Machines/Models: UL25, UL32, SB97.4

**UL40 Serial Nos.:** 17049-17116

#### THIS BULLETIN IS MANDATORY.

PURPOSE: To replace lift cylinder assembly on above models.

Figure 2

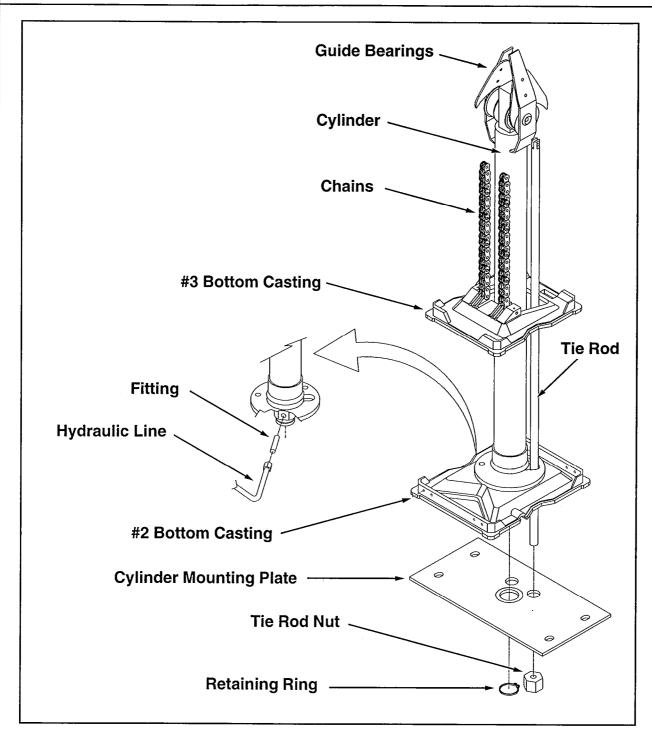
1. Remove cylinder mounting plate fasteners and retaining ring.

2. Remove tie rod nuts.

- 3. Remove the cylinder mounting plate. Be careful not to allow the tie rods to suck back inside of the mast assembly, replace the nuts on the tie rod ends temporarily to prevent this.

Figure 3

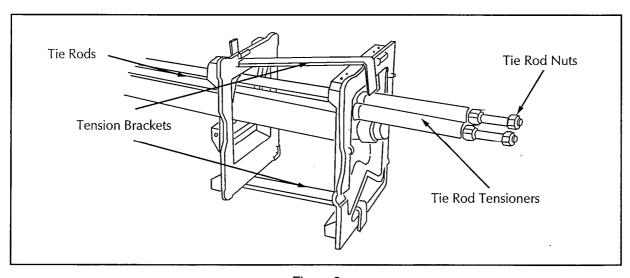
- 9. Install cylinder tension brackets on #2 and #3 bottom castings per figure 3. Remove tie rod nuts and install the tie rod tensioners per figure 3. Remove all slack from the chains by tightening the tie rod tensioners.

NOTE: Cylinder assembly must have Tension Brackets, and Tie Rod Tensioners installed per figure 3 prior to installation.

Figure 4

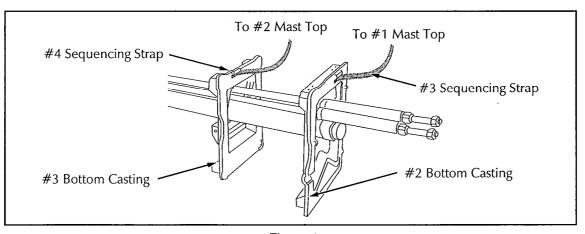
- 1. Slide cylinder assembly into mast assembly until #3 bottom casting is near the bottom of the mast assembly.
- 2. Slide #4 strap through the slot in #3 casting and lay aside.

- 3. Remove the tension brackets and push the #3 casting the rest of the way into the #3 mast.
- 4. Install the screws and washers attaching the #3 bottom casting to the #3 mast assembly. Use Loctite® #242 or equivalent screw lock compound.

- 5. Fish #4 strap up between #3 and #2 mast with fish tape.
- 6. Remove tie rod tensioners from tie rods. Install tie rod nuts finger tight.
- 7. Slide #3 strap through the slot in #2 casting and lay aside.

Figure 5

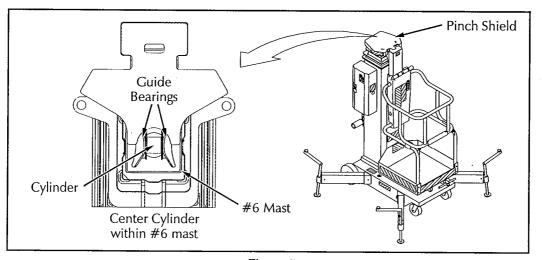
- 18. Remove pinch shield (figure 5) from the top of the mast assembly and check alignment of the cylinder within the mast assembly by looking down the inside of the mast with a flashlight. The cylinder guide bearings must not be touching the inside surface of #6 mast. Center the cylinder within the mast assembly by tightening the left or right tie rod nuts to move the cylinder left or right respectively. Fore / aft alignment may be achieved by shimming between #3 bottom casting and the cylinder base. If fore / aft alignment is necessary, contact UpRight product support department to obtain shims and instructions.

- 19. Replace the pinch shield to the top of the mast assembly.
- 20. Bleed air from cylinder by cycling the mast to full extension several times. The cylinder is self bleeding, and air will be forced out during the lowering cycle.
